SPECIFICATION CONTROL DRAWING

D4305-041 SHOULDER HARNESS

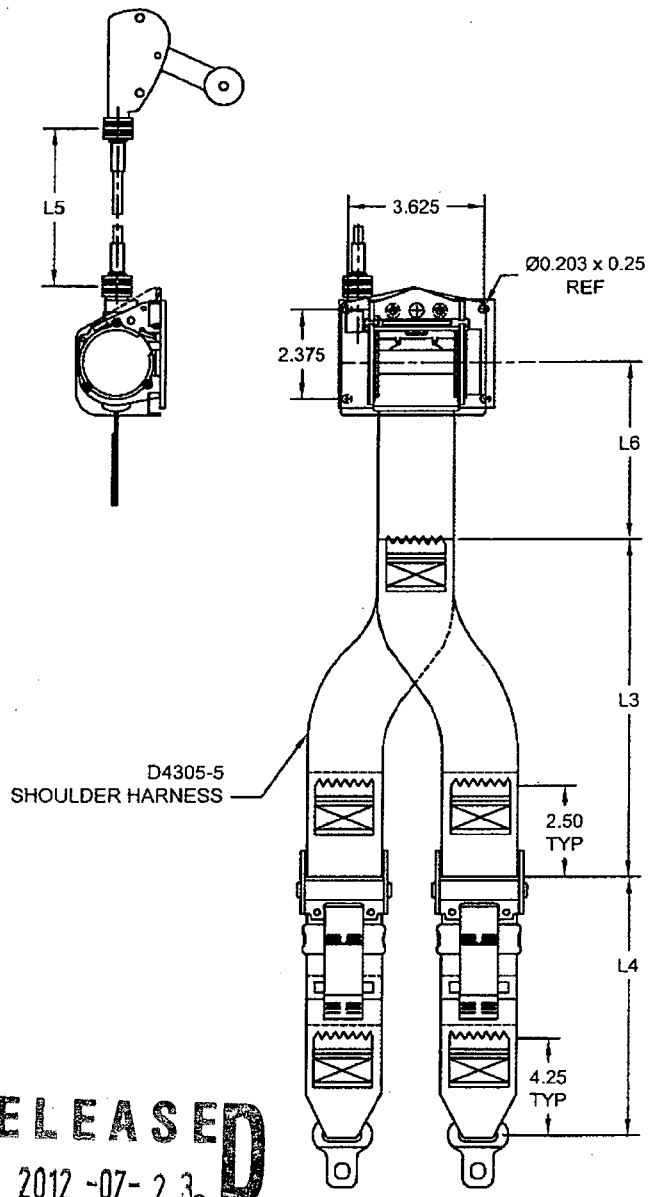
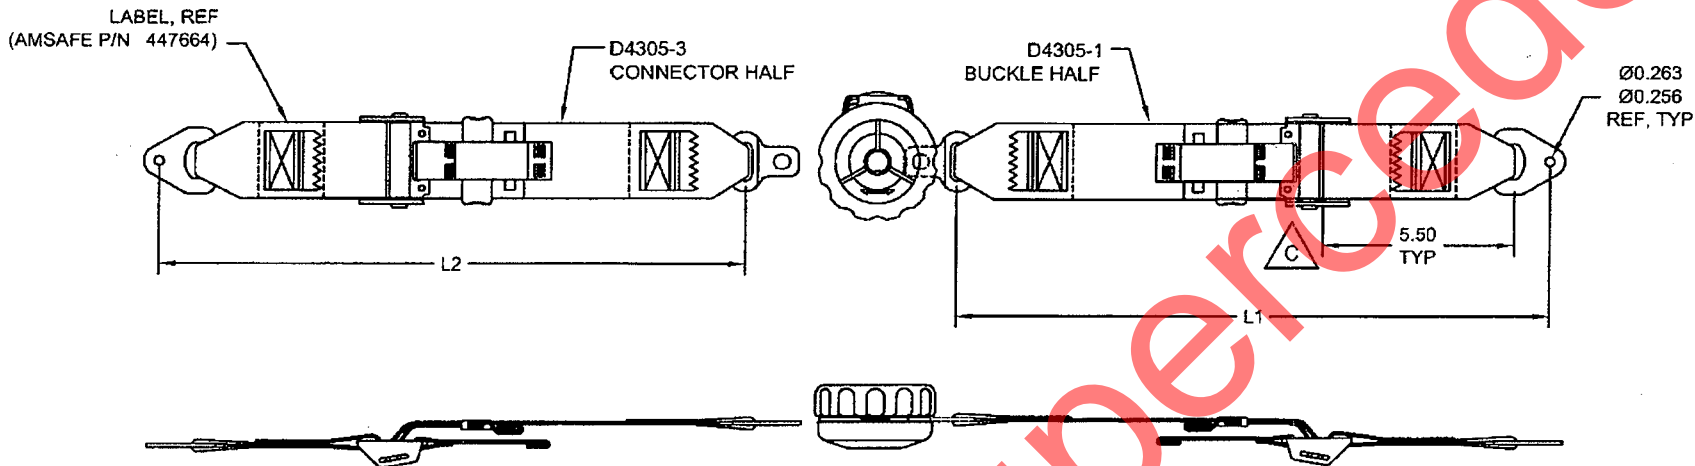
C	5.50 WAS 4.00, L3 WAS 49.00, L4 WAS 4.00 - 26.00	RP	12.07.03
B	REVERSED ORIENTATION OF ADJUSTER ASSEMBLIES ON D4305-1 AND D4305-3. L1 & L2 WERE 24.00. L4 REDEFINED. L3 WAS L5 AND WAS 18.00. L6 ADDED. L5 WAS L6 AND WAS 30.00. UPDATE AMSAFE PART NUMBERS.	RP	12.05.25
A	NEW ISSUE	RF	10.11.26
REV.	DESCRIPTION	BY	DATE
DESIGN	RF	DART AEROSPACE LTD HAWKESBURY, ONTARIO, CANADA	
DRAWN	RP		
CHECKED	A.P.	DRAWING NO.	REV. C
MFG. APPR.		DSC-D4305	SHEET 1 OF 1
APPROVED		TITLE	SCALE
DE APPR.		SHOULDER HARNESS	NTS
DATE	12.07.03	COPYRIGHT © 2010 BY DART AEROSPACE LTD THIS DOCUMENT IS PRIVATE AND CONFIDENTIAL AND IS SUPPLIED ON THE EXPRESS CONDITION THAT IT IS NOT TO BE USED FOR ANY PURPOSE OR COPIED OR COMMUNICATED TO ANY OTHER PERSON WITHOUT WRITTEN PERMISSION FROM DART AEROSPACE LTD.
